Re: PLUS review – PLUS 2005-11-04; Nentego

This letter is in response to comments received from the Delaware Office of State Planning Coordination following the PLUS review of the Nentego in Sussex County, Delaware. The PLUS Comments are included herein with [our responses in blue.]

Map of Nentego with affected parcels in light blue and wellhead protection areas in dark red.

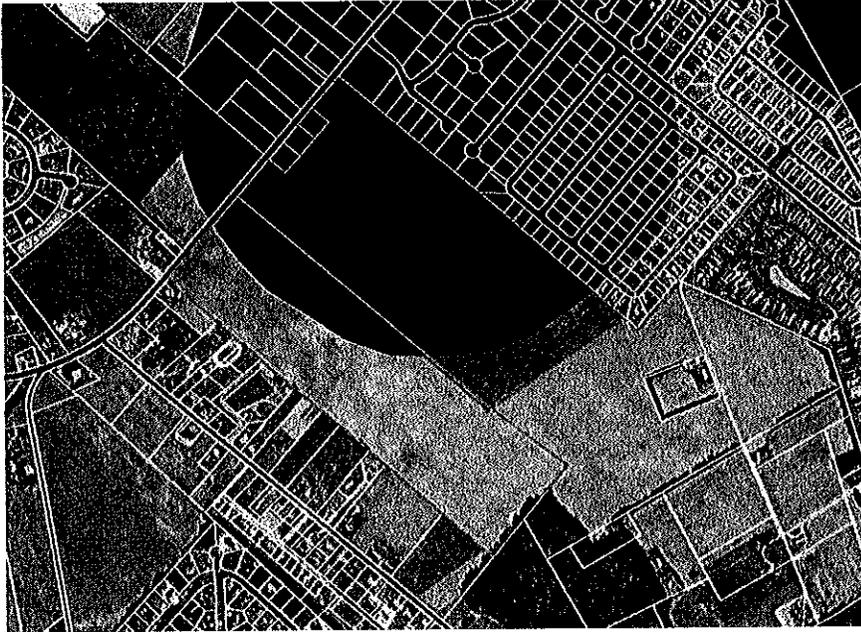
The DNREC Water Supply Section has determined that it does fall within a wellhead protection area for Tidewater Utilities (Meadows District). Most of the northern parcel and a section of the southern parcel are covered by a wellhead protection area (see following map and attached map). Wellhead protection areas are surface and subsurface areas surrounding a public water supply well where the quantity and quality of groundwater moving toward such wells may be adversely affected by land use activities.

The DNREC Water Supply Section recommends that the portion of the new development within the wellhead protection area not exceed 50% impervious cover. Further, some allowance for augmenting ground-water recharge should be considered if the impervious cover exceeds 20% but is less than 50% of that portion of the parcel within this area. The purpose of an impervious cover threshold is to minimize loss of recharge (and associated increases in storm water) and protect the quality and quantity of ground water and surface water supplies. [Efforts have been made in this design to reduce the amount of proposed impervious area within the wellhead protection area.]

The proposed development would change the impervious over from 0% to approximately 24.1%. These numbers were provided by developer on the PLUS application. The development plan includes 57.65 acres of open space. Ideally, relocating open space areas to the northern parcel and the northern part of the southern parcel would decrease the total impervious area in the wellhead protection area. Augmenting the groundwater recharge with clean rooftop run-off systems are another alternative to reducing the total impervious cover in the wellhead protection area. [The developer has revised the site plan to eliminate the 12 unit apartment buildings, thus eliminating the proposed large impervious parking areas for each 12 unit building.]
